Product Change Notification

PRECISION POTENTIOMETERS

New Varnish Application Process for Wirewound and Hybrid Elements

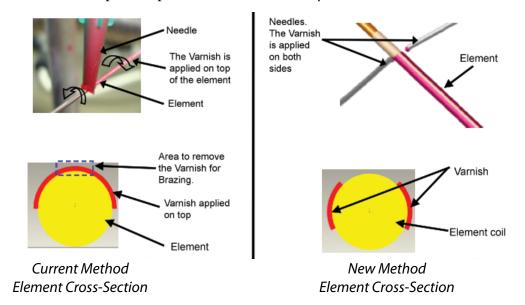
Currently, varnish is applied on top of the element to hold the resistive wire in place on the mandrel. Later, this varnish is removed in the brazing area (only) with a sand blast process. This process requires special control in timing, pressure and flow to ensure that no damage is done to the element where the brazing is to occur. Finally, the element is washed with special chemicals to remove the residue from the blasting process.

A new method has been developed to apply varnish on both sides of the element, leaving the brazing area free of varnish. The new process does not require removal of varnish in the brazing area, thereby eliminating potential residue of media left by the blasting process.

The graphics below show the current and new processes side by side. The new procedure is a change of production process; however, product performance and reliability are unaffected.
